BALTIMORE COUNTY, MARYLAND
DEPARTMENT OF PUBLIC WORKS AND TRANSPORTATION
DIVISION OF CONSTRUCTION CONTRACTS ADMINISTRATION
111 WEST CHESAPEAKE AVENUE
TOWSON, MARYLAND 21204

Contract Number 20151 SX0
Whitemarsh East Sewershed Sewer Rehabilitation
Perry Hall – District 11, 14, 15 c 5&6
Workday Number 010777253
Job Order Number 231-201-0077-7253

ADDENDUM NO. 1

DATE: 5/26/2026

PLAN: C1300 - MH 11424 / MH 73748 - MH 11424
SCALE: 1" = 30'

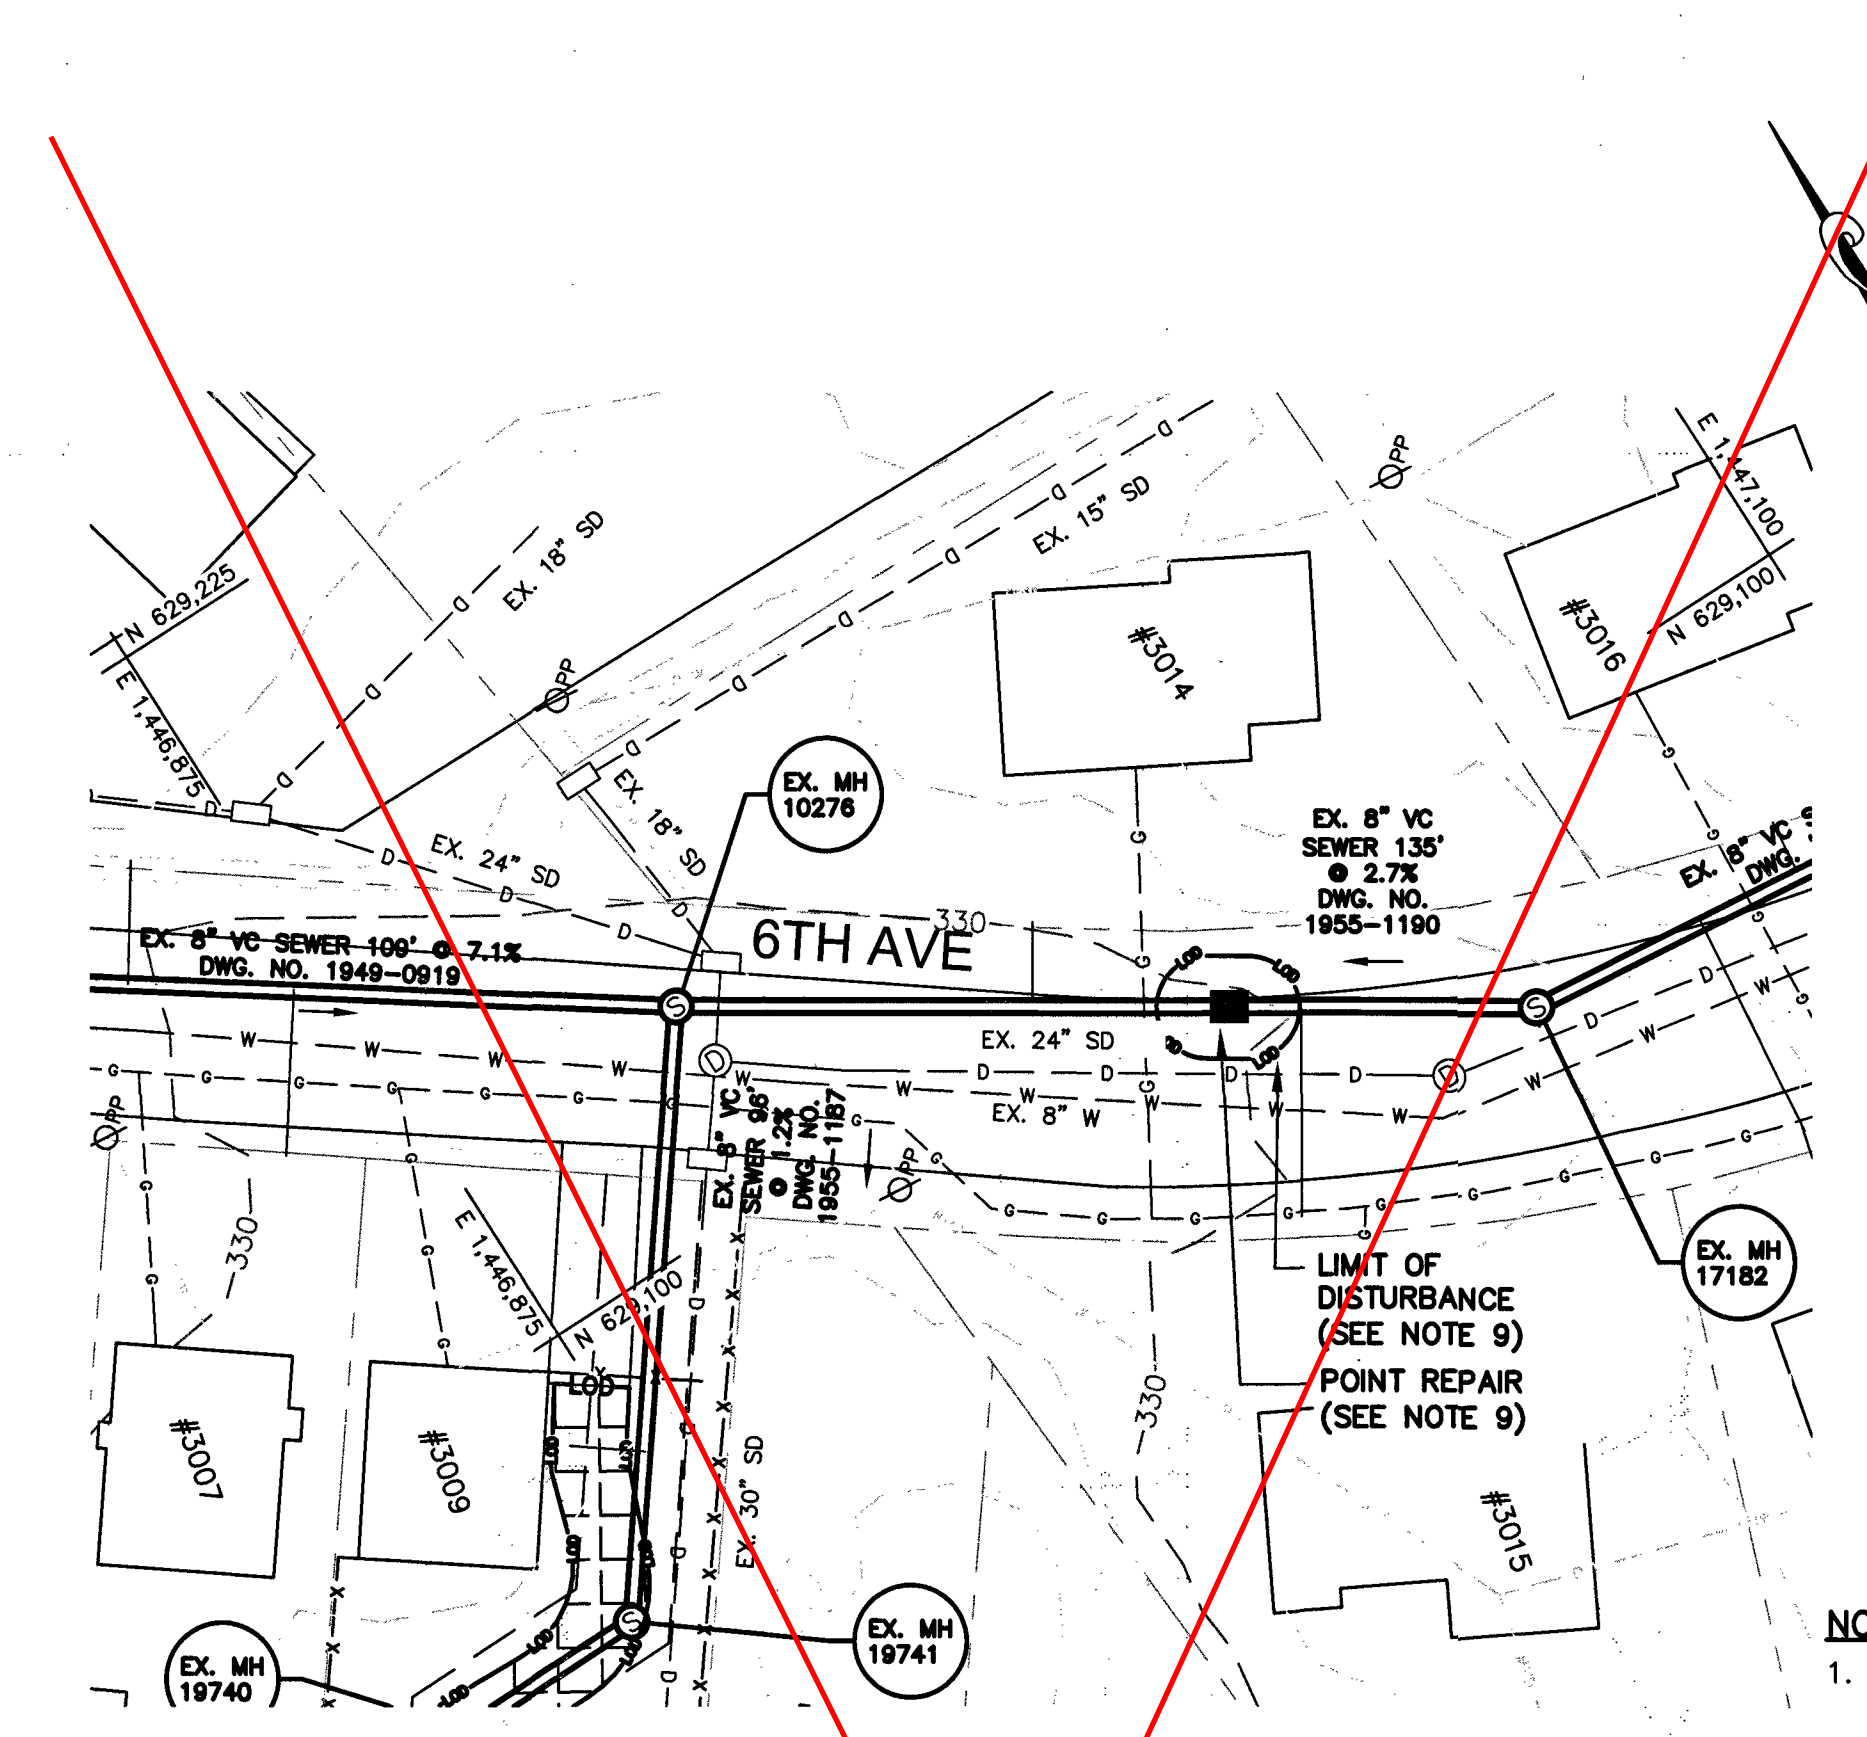
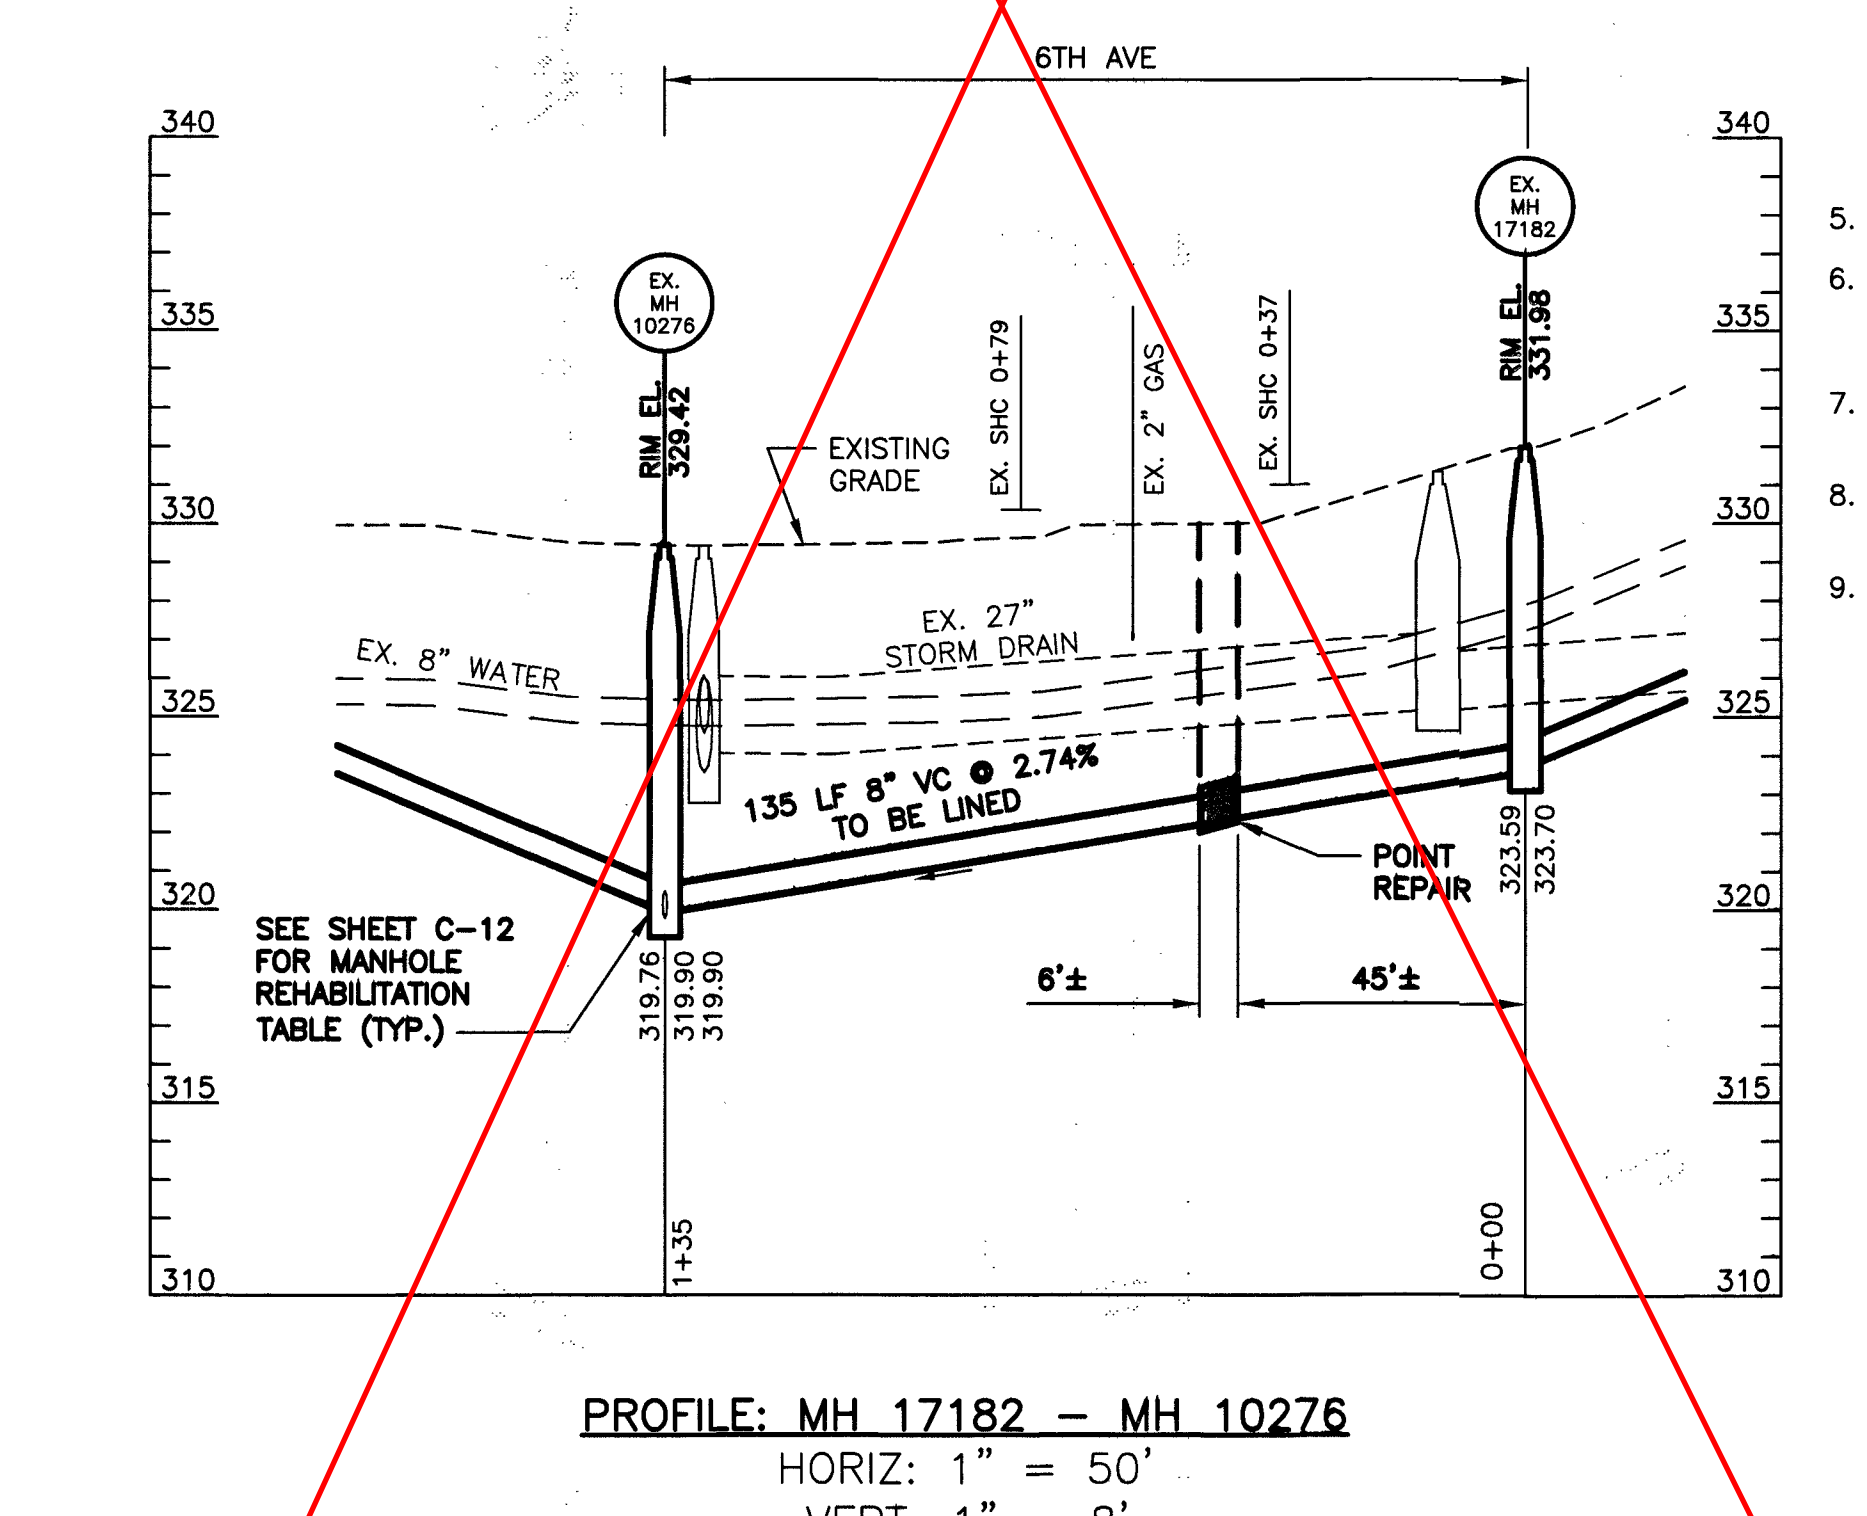
Drawing C20-A and C40-A – **ADD** a new manhole and perform 53 linear feet of 8” CIPP pipe lining. This work is begin added from a previous project.
